UNITED STATES
DEPARTMENT OF THE INTERIOR
BUREAU OF LAND MANAGEMENT

SUNDRY NOTICES AND REPORTS ON WELLS
Do not use this form for proposals to drill or to re-enter an abandoned well. Use Form 3160-3 (APD) for such proposals.

8. Well Name and No.
TNT 6 FEDERAL COM #1

PROPOSED PLUG & ABANDONMENT

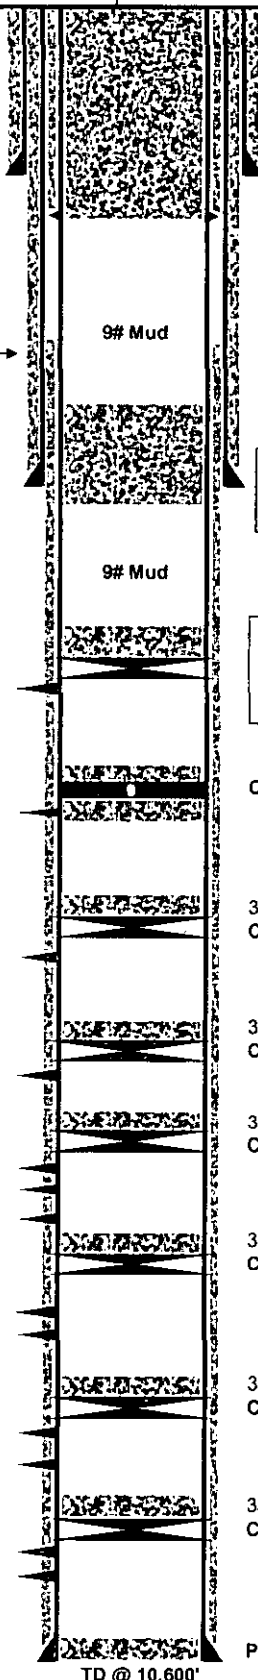
1. MIRU P&A Unit. POOH w/rod pump and 2-7/8" production tubing from 4,057'.
2. Set CIBP @ 3,860' Tag. Spot 25 sx (250') CI C @ 3,860' - 3,640' Tag TOC. 3840 - 3590'
3. Spot 40 sx (400') CI C @ 2,710' - 2,310'. Tag TOC. (8-5/8" shoe @ 2,658').
4. Perf 5-1/2" casing @ 700'. Pump 165 sx CI C in/out from 700' to surface. (B.Salt @ 680'; Csg shoe @ 383'; T.Salt @ 280')
5. Cut wellhead off. Set dry hole marker. 730

Proposed: 3840 3590
2. Spot 25 sx (250') Cl C @ 3,860' - 3,610'. Tag TOC.
1. Set CIBP @ 3,860' Tag.
3840
